ANACORTES PLANNING COMMISSION

MEETING AGENDA

September 9, 2020

1. **Roll Call**
2. **Minutes of August 26, 2020** Will be presented at a later date.
3. **Correspondence**
4. **New Business**
 - a. **Public Hearing:** SDP-2020-0001 – Tom Jackson Dock
 - b. **Public Hearing:** SPL-2020-0003 – Cherry Court Short Plat and CUP

OVERALL SITE PLAN		PLAN STATUS:	
SCALE: 1"=30'	DRAWN BY: HLN	SHEET TITLE:	CITY ENGINEER
CHECKED BY: HLN	DATE: 08.06.20	CHERRY COURT SHORT PLAT FOR CORNER 9 PROPERTIES, LLC SW 1/4 SECTION 25, T. 35 N., R. 1 E., W.M.	DATE
		DRAWING NO. 19013SITE.dwg	JOB NO. 19013
		SHEET NO. 3 OF 11

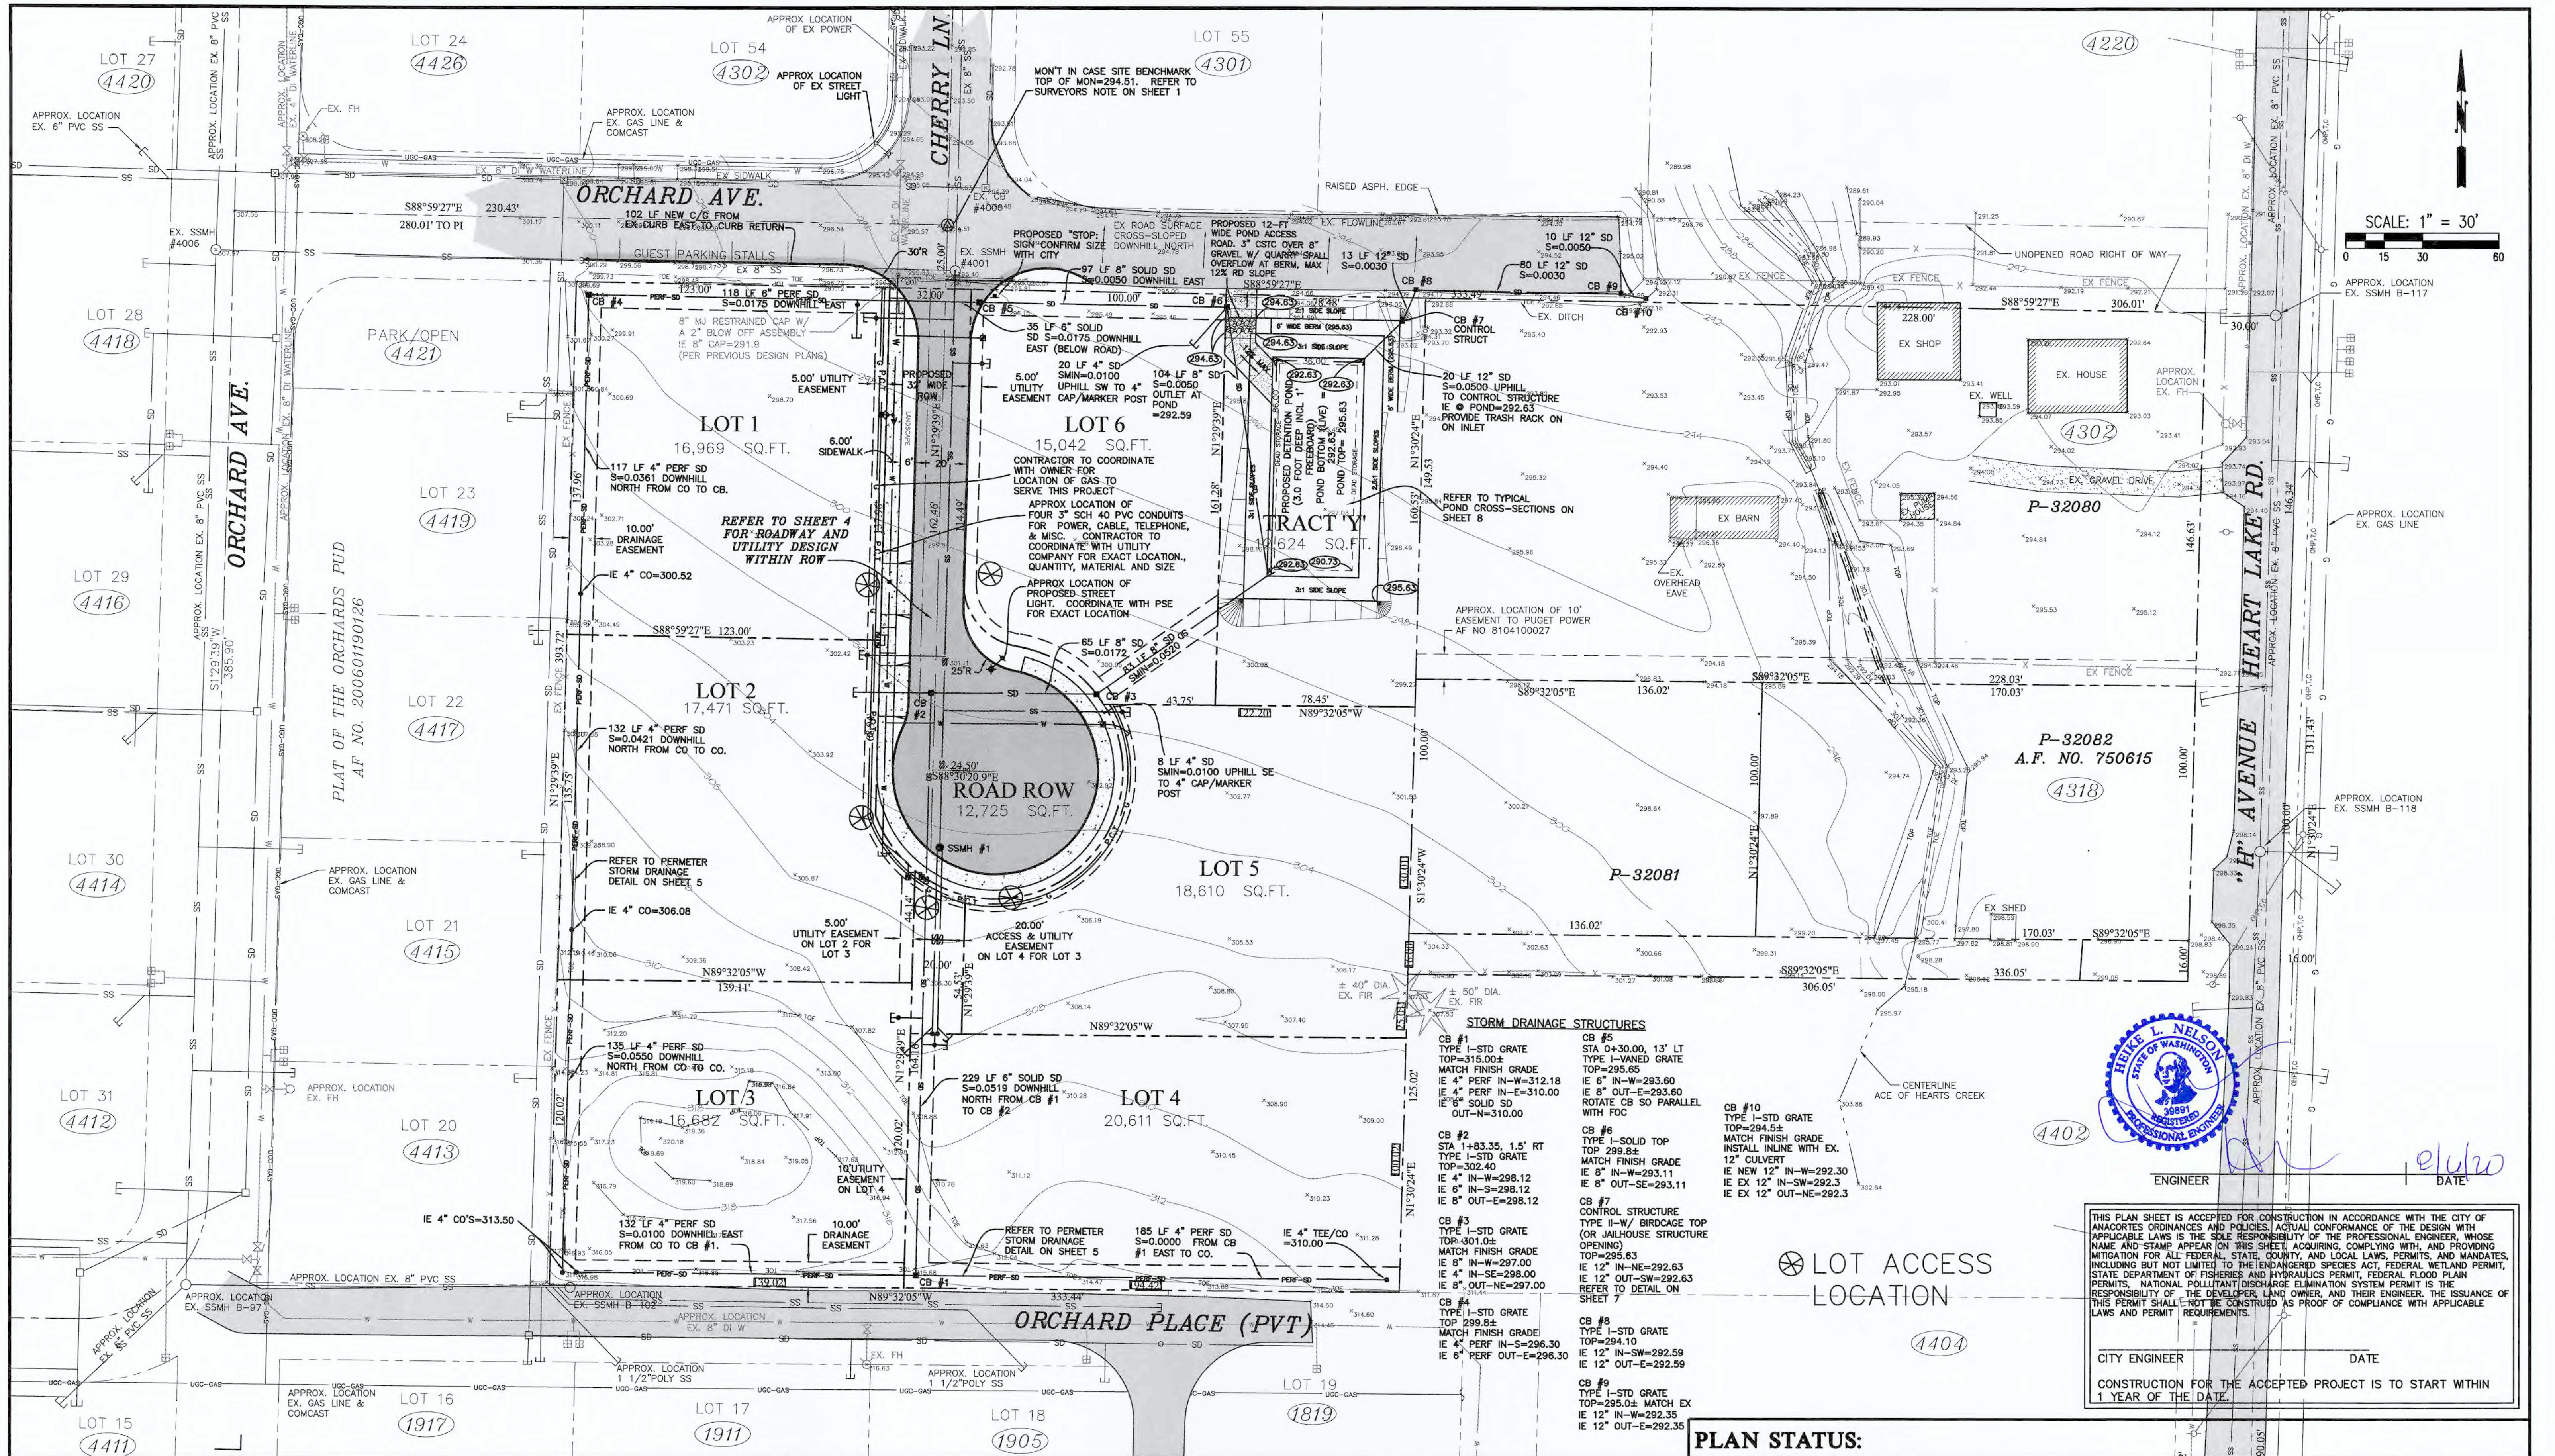
10. Catch Basin 2 appears to be the only catch basin shown to collect runoff from the cul-de-sac area yet the contours on Sheet 5 are generally pointed away from Catch Basin 2. Likewise, Catch Basin 5 does not look adequate to collect the remaining road runoff. At a minimum, an additional catch basin should be placed west of Catch Basin 5 to ensure runoff is collected on the west side of the road. The current 6-inch perforated pipe being shown across the road could be replaced with a solid pipe. Adequate cover needs to be ensured for this pipe. In general, please ensure there are enough catch basins to appropriately collect road runoff and that the grading is appropriate.

2. Sheet 3: Return radius on the east side of intersection at Orchard Avenue needs to be a 25' Radius for street sweeping.

3. Sheet 3: Utility easement between Lot 5 and Lot 6- clarification question, a total of 20-feet to the City of Anacortes? Or 15' to the City of Anacortes and 5-feet to P32081?

4. Sheet 3: Utility easement between Lot 5 and Lot 6: Turning radius for vac truck to reach structures. In other areas, we have similar designs, but when the property owner constructs a fence or large retaining wall at the corner, the radius is significantly reduced.

5. Sheet 3: P32081 appears to be land locked from any street frontage or access. Where is the frontage considered for this property?

6. Sheet 3: Monument in case installed in the Cul-de-Sac as well. Per EDS Standards, Chapter 3 - Streets, Section STR-25 Monuments.

Catch basin information for CB's 2 and 5 is located on the plan and profile sheet. We have additionally added catch basin structure information to the bottom right-hand corner of sheet 3 for all catch basins for clarity.
